Serial No. 10/657,025

: NUCLEAR REACTOR

: FUEL ASSEMBLIES

PETITION UNDER 37 CFR § 1.181

FIG. 6

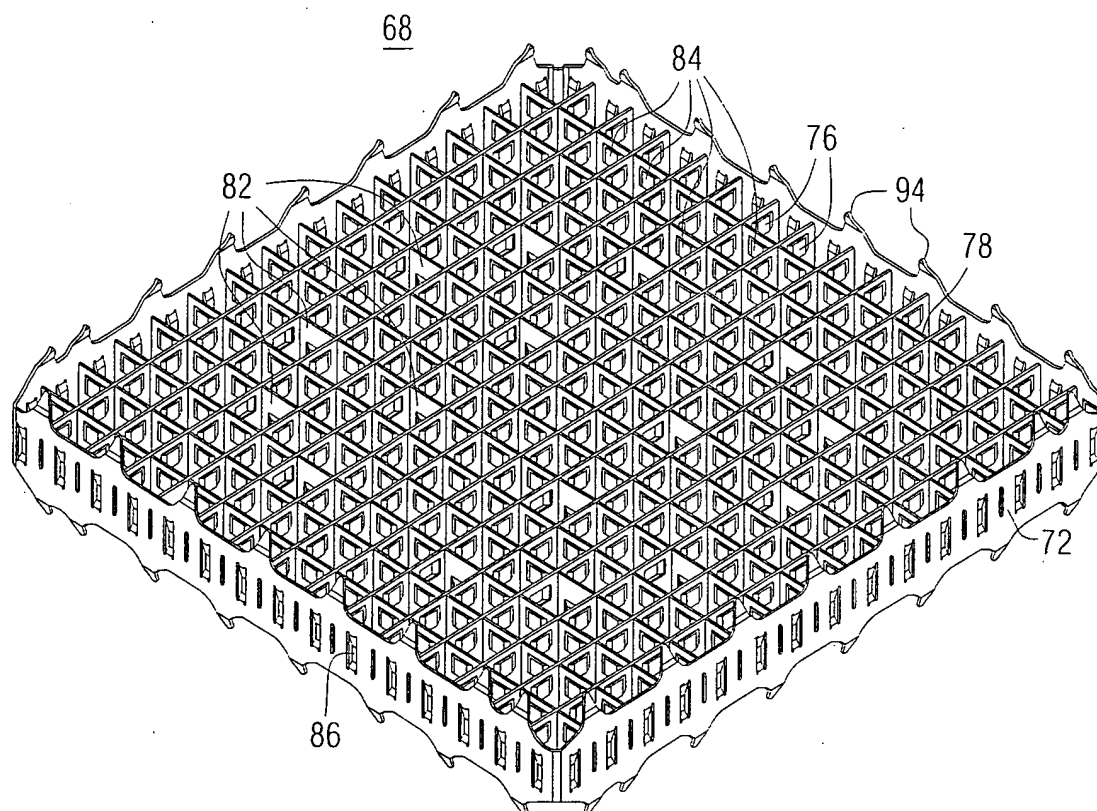
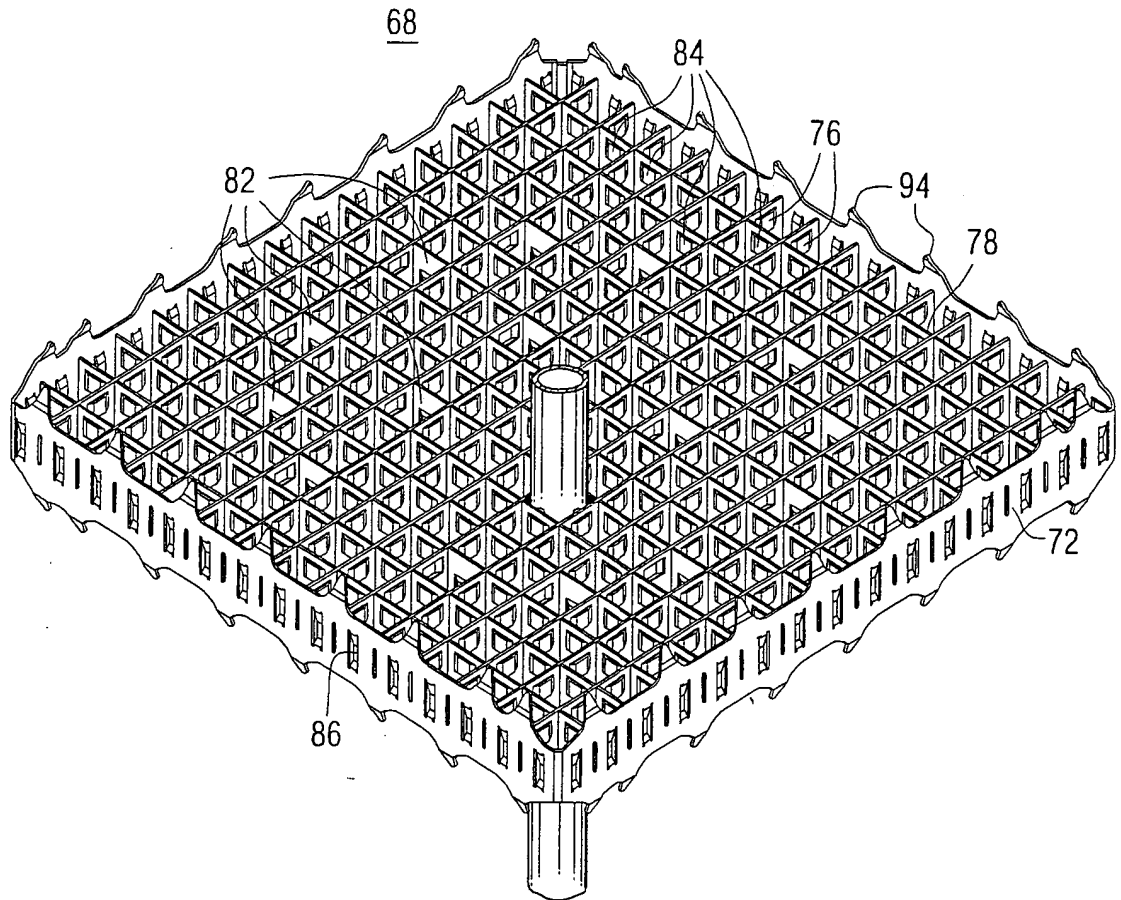
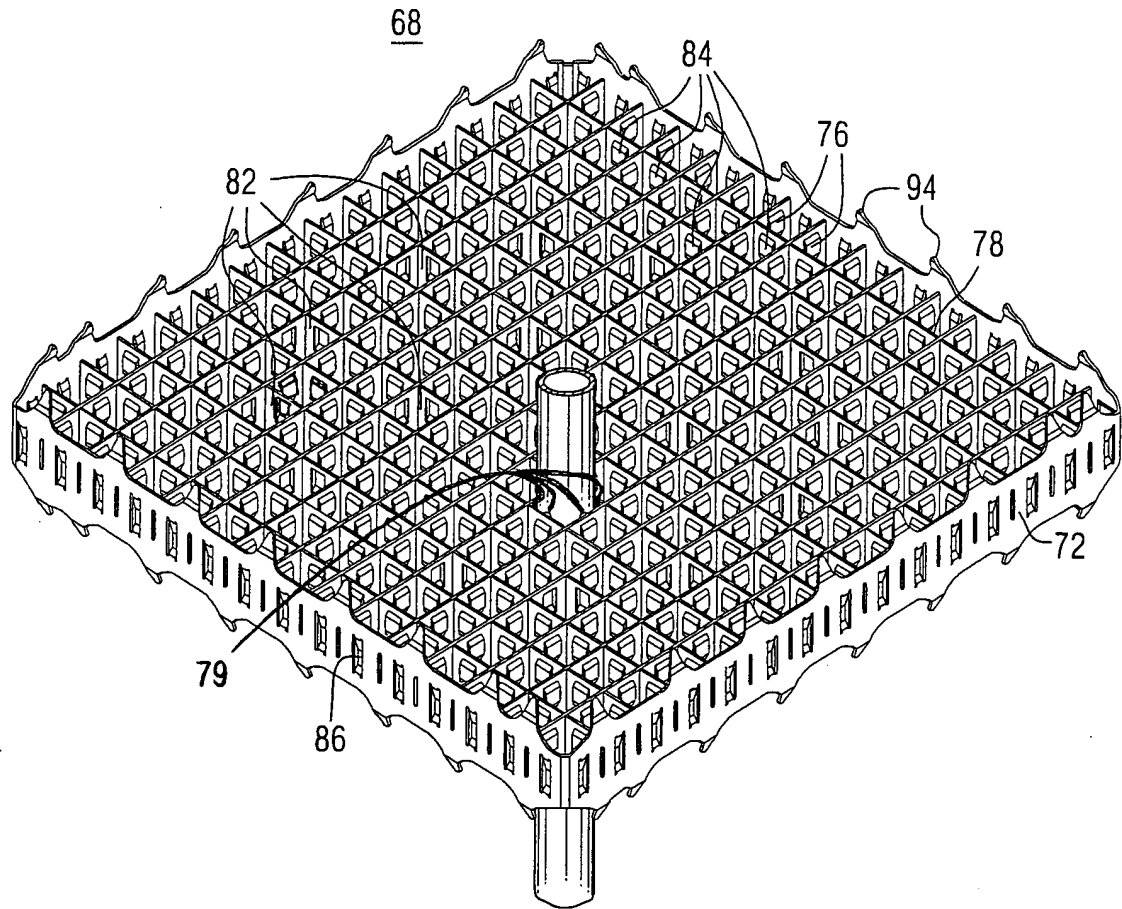
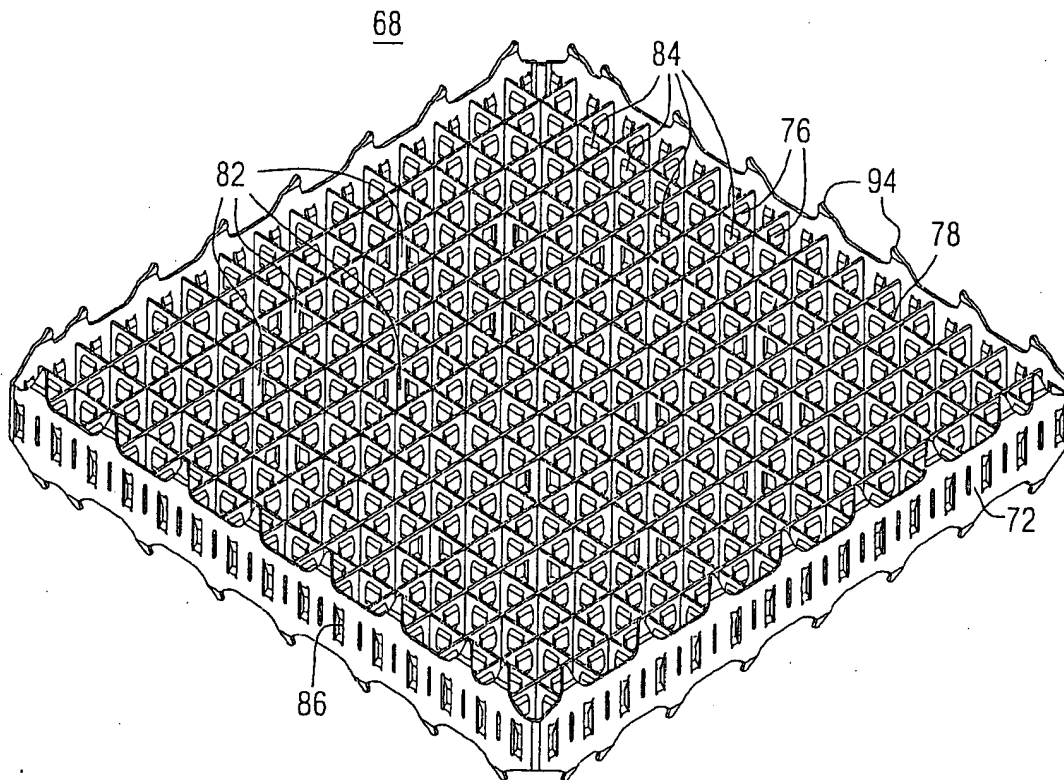
Despite applicants' arguments to the contrary, it is not seen wherein Fig. 6 shows both vertical springs and dimples on the inner straps nor does it show a common plane intersecting both the vertical springs and the dimples.

Amended Fig. 6 does not clearly show a guide tube attached at the cell corners by butt-welds (it is not known what the slightly darkened portions at the two illustrated diagonal corners of the cell (through which the guide tube passes) is supposed to represent).

The Examiner further objected to the amendment to the specification, stating that Fig. 6 shows a 15x15 array, not a 17x17 array.

Figure 6 shows vertical springs on the outer strap of the auxiliary grid, it does not show vertical springs on the inner strap. The inner strap only shows a horizontal dimple at the upper end of the cell wall.

It is immaterial as to whether Figure 6 shows the outer strap of the auxiliary grid as having vertical springs because the claimed relative difference in contact area of the dimples and/or springs, is with the inner straps of the two different grids.

Despite applicants' arguments to the contrary, it is not seen wherein Figure 6 shows both vertical springs and dimples on the inner straps, nor does it show a common plane intersecting both the vertical springs and the dimples.

It is respectfully asserted that applicants have complied with this requirement. In Paragraph 2 of the Office Action, the Examiner has asserted that Fig. 6 (in Exhibit D) has not been approved as it is drawn to new matter. It is respectfully asserted that the amendments to Fig. 6 were merely made to conform the drawings to the description in the specification as quoted above. Therefore, the same should not be considered new matter.

In a response mailed February 22, 2005, applicants amended Fig. 6 (attached hereto as Exhibit C) showing the welds attaching the control rod guide tubes to the grid cell in a more pronounced fashion and labeling them with reference character 79. Reference character 79 was also added to the corresponding description in the paragraph spanning pages 11 and 12. Fig. 6

was also amended to better show that the springs in the grid cells that have springs, i.e., fuel rod support cells are co-planar and are oriented in the vertical direction. Support for both of these changes can be found on page 11 of the specification. The specification was additionally amended to correct the reference to Figs. 4 and 6 in the paragraph beginning on page 9, line 24. It should be clear from the figures that Fig. 6 illustrates a 15x15 array and Fig. 4 shows a 17x17 array. In the Remarks/Arguments section of the response of February 22nd, applicants identified that they disagreed with the Examiner that the drawings did not show the relative size of the contact areas of the dimples and/or springs of the auxiliary support cells versus the main support cells, and that the features of Claims 9 and 13 were not shown. However, for the sake of advancing prosecution, applicants have further amended Fig. 6 to clearly show that the dimples and/or springs are on the vertical and they are all within the same plane. Applicants directed the Examiner's attention to Fig. 5, which shows the springs of the traditional grid on a diagonal with the contact area shown relative to the width of the cell as being substantially less than that shown for the vertical springs and dimples shown in Fig. 6 relative to the cell wall width illustrated in Fig. 6. In support of this proposition, applicants cited the Federal Circuit in *Hockerson-Halberstadt Inc. vs Avia Group International, Inc.* (222 F.3d 951, 956, and 55 USPQ F.2d 1487, 1491, Federal Circuit 2000) which stated: "It is well established that patent drawings do not define the precise proportions of the elements and may not be relied on to show particular sizes if the specification is completely silent on the issue". In this instance, the specification does add to the drawings by clearly stating on page 11, starting at line 6, that the dimples and/or springs are co-planar and, on line 8, that the springs are on the vertical rather than on the diagonal. Starting at line 29, the specification specifically states: "The inner straps 76 and 78 on the auxiliary grids provide for a larger contact area between the dimples/springs and the fuel elements than are provided by the corresponding contact areas on the main support grids 46". Applicants also cited the opinion of the Court of Customs and Patent Appeals stated in *In re: Chitayat*, 408 F.2d 475, 161 USPQ 224 (1969) that: "Arguments based on mere measurement of patent drawings are of little value in the absence of a description in the specification of relative dimensions. Here, we have both a clear statement in the specification and the relative dimensions of the prior art springs shown in Fig. 5 relative to the width of the cells walls as compared to those of the invention shown in Fig. 6. Applicants also cited the opinion in *In re: Wilson* 312 F.2d 449, 454, and 136 USPQ 188, 192 (CCPA 1963), which stated: "Patent drawings are not working

On May 5, 2005, applicants submitted a Request for Continued Examination and entry of an amendment enclosed therewith, which modified Fig. 6 (attached hereto as Exhibit D) as previously amended as shown in Exhibit C attached herewith and discussed with the Examiner

Applicants are at a loss as to what the Examiner is referring to, because the amendment provided to Fig. 6 in Exhibit D, which accompanied applicants' Request for Continued Examination, clearly shows the springs and/or dimples on the inner straps in a vertical orientation, all on the same plane. 37 CFR § 1.83(a) provides:
